STAFF RECOMMENDATION
1718 Greenwood Avenue
March 16, 2016

Application: Alteration to permit
District: Eastwood Neighborhood Conservation Zoning Overlay
Council District: 06
Map and Parcel Number: 08302027500
Applicant: Urban Development Group, LLC
Project Lead: Melissa Baldock, melissa.baldock@nashville.gov

Description of Project: Application is to alter the existing permit for infill with a front yard parking pad.

Figure 2. The site plan approved by MHZC in 2015.

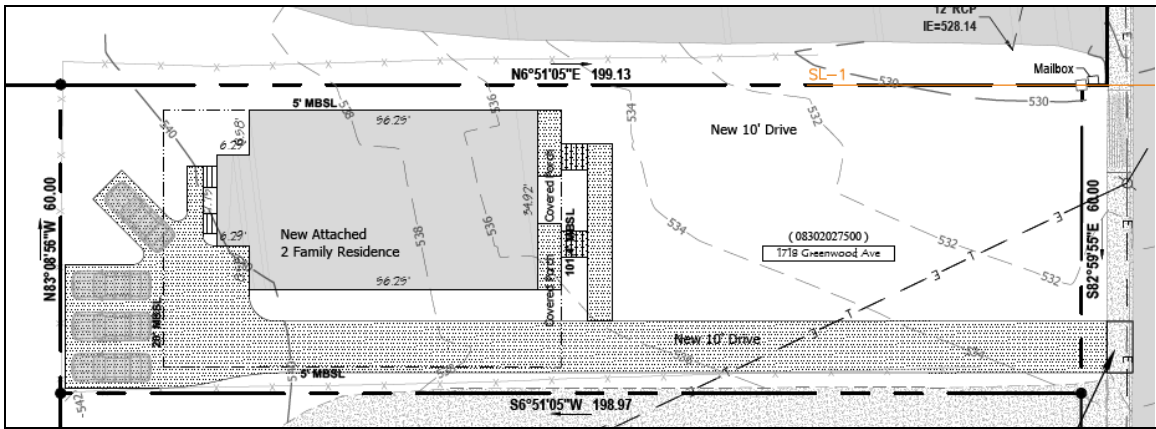
The site plan the Commission approved provided for four parking spaces (two for each duplex unit) at the rear of the site (Figure 2). However, a retaining wall was constructed

approximately six to ten feet (6'-10') off of the left side property line, and approximately four feet (4') off the rear property line. The retaining wall in this location reduced the area in the rear for parking (Figures 3 – 6).

Figure 7. Proposed parking plan for the duplex.

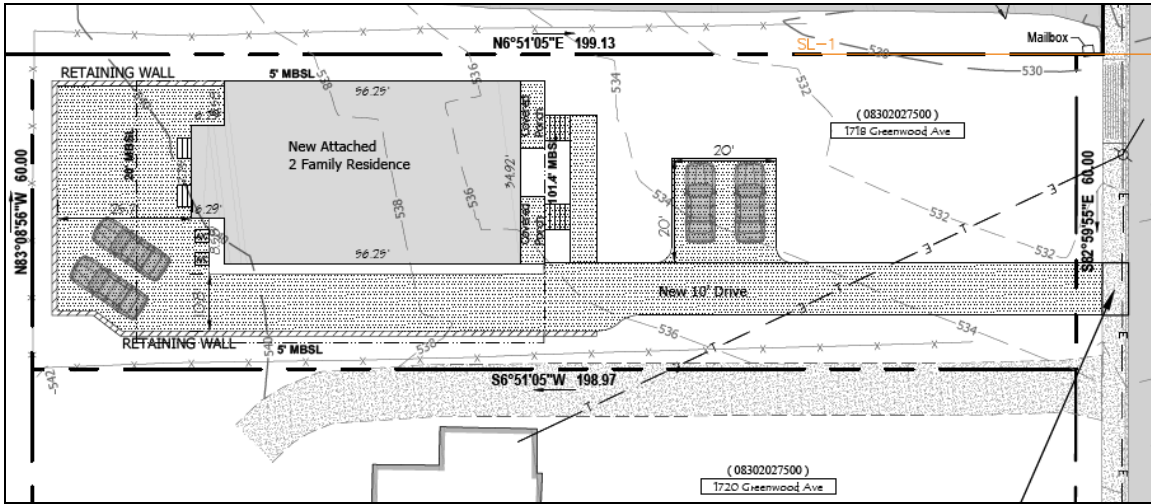
Orientation: The applicant is proposing parking for two cars in the rear of the property, behind the house, and for two other cars in the front yard, accessed via the existing driveway and curb cut (Figure 7). The front yard parking pad will be twenty feet by twenty feet (20' X 20') and will be located in front of the house. It will be located approximately sixty feet (60') from the front property line and will be approximately twenty-three feet (23') from the infill's front porch.

The design guidelines require that a building's front façade be visually consistent with the surrounding historic properties. Because other buildings with similar setbacks have parking at the rear, staff finds that cars parked in the front yard will change the look of the front façade in a manner that would not be within keeping with the historic context. This is consistent with the Commission's past decisions which are clarified in the italicized language which state that "*Front yard parking or driveways which end at the front of the house are not consistent with the character of the historic neighborhoods.*"

If the retaining wall were to be moved back to its original location, staff believes there would be enough room for the original four rear parking pads. Staff therefore finds that the proposed front yard parking pad does not meet the design guidelines or the historic context of the Eastwood neighborhood.

Staff recommends disapproval of the proposed front yard parking plan, and recommends that the applicant provide parking for four vehicles behind the historic house, even if that requires the relocation of the retaining wall.
